# EAST SIDE COASTAL RESILIENCY PROJECT

COMMUNITY ENGAGEMENT SESSIONS: INITIAL DESIGN DIRECTION

## PROJECT AREA 1&2 SUMMARY REPORT

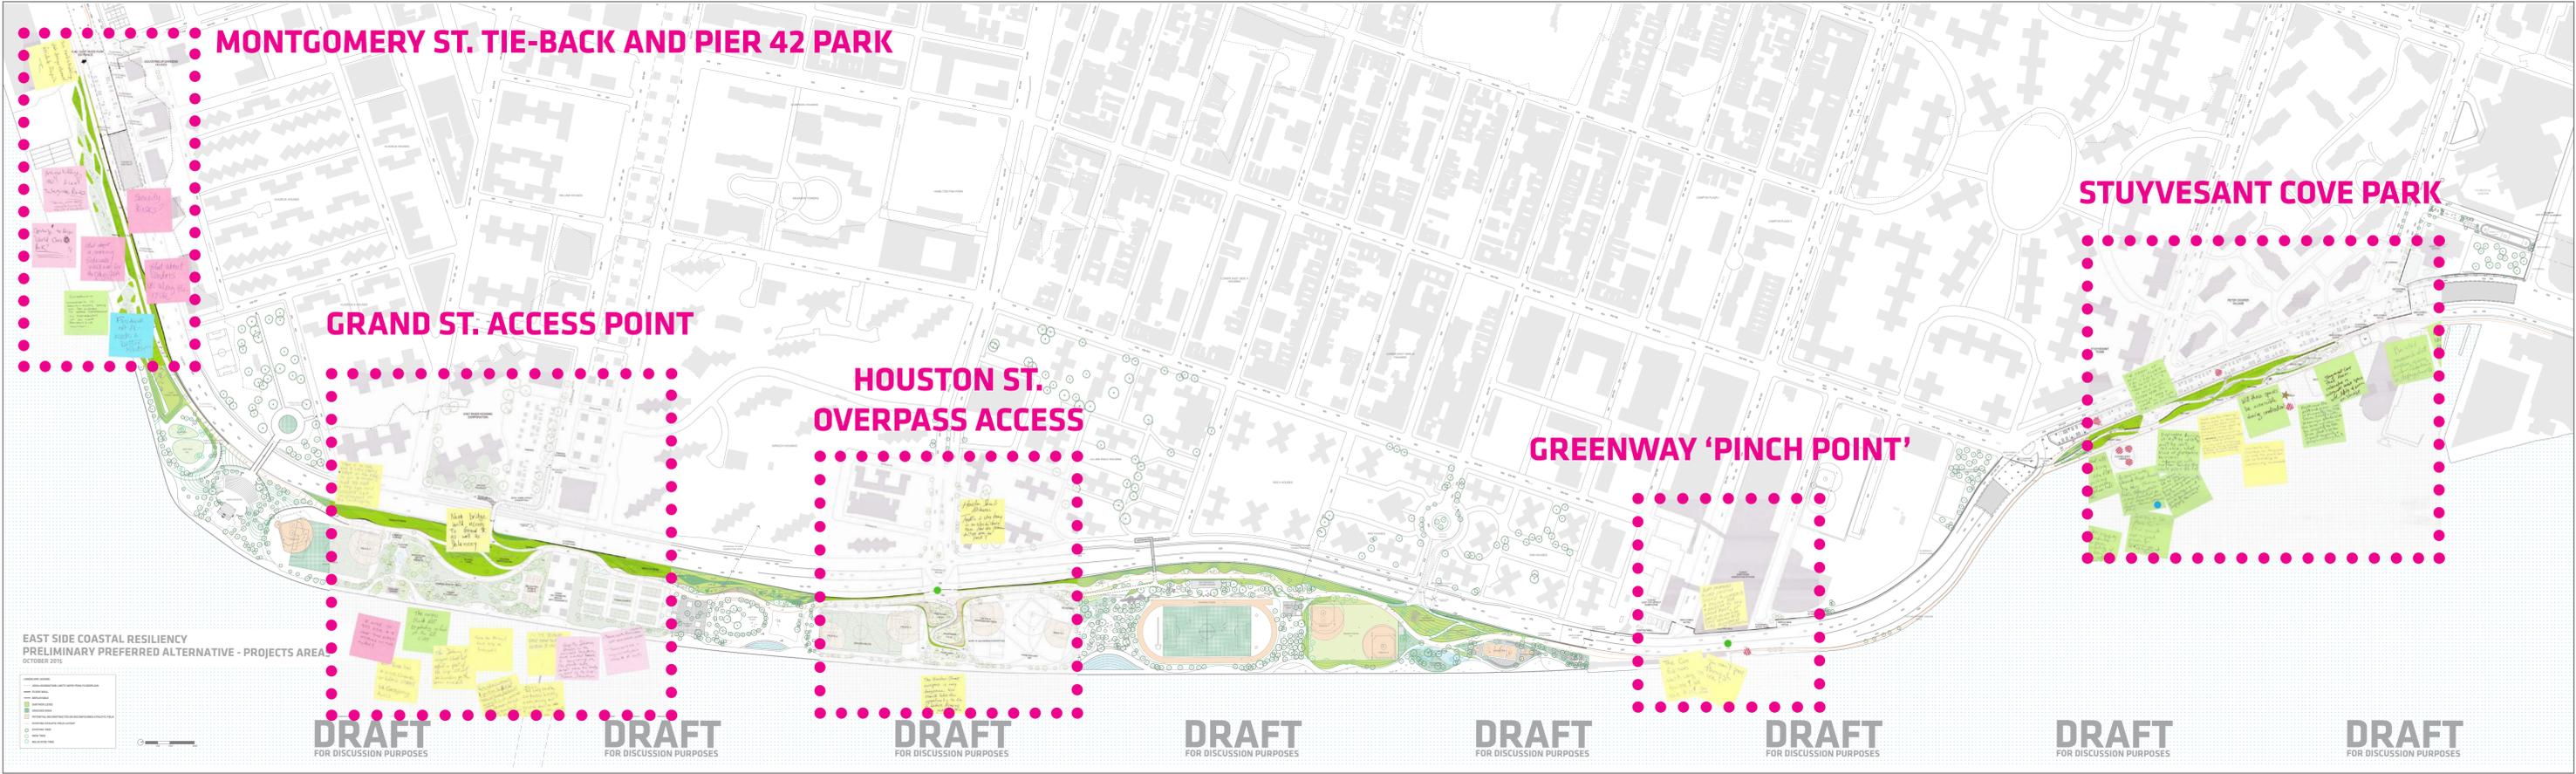
- Residents sought more information about the look and feel of the preliminary flood protection alignment along Pier 42 and at the Montgomery St. tie-back
- Participants raised concerns about the appearance of the flood protection wall, as viewed from the city side
- Several participants inquired about the integration of the Pier 42 Phase I master plan with the ESCR project
- The design of the Grand St. access point remains an unresolved issue and will be refined in close consultation with residents
- Participants solicited additional information about DOT's circulation improvements to the Houston St. overpass
- At E10th St., participants stressed the need to preserve and/or enhance these uses: BBQ area, playground and bathrooms
